Product Change Notification

Change Notification #: 112739 - 01
Change Title: Intel® Server System R1208BB4GS9 and R2308BB4GC
PCN 112739-01, Product Design
Update System PSU Bracket
Reason for Revision: Correct TA#
Date of Publication: May 25, 2014

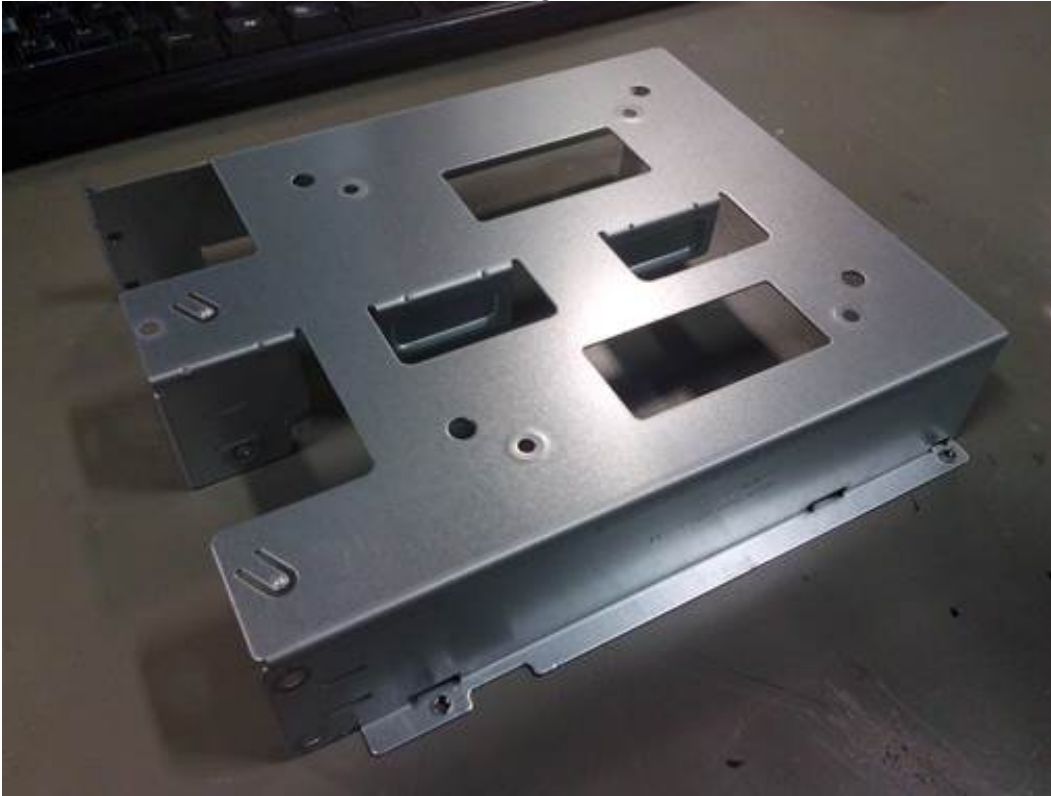
Update the Power Supply bracket to remove middle punch. Please refer to below pictures for details:
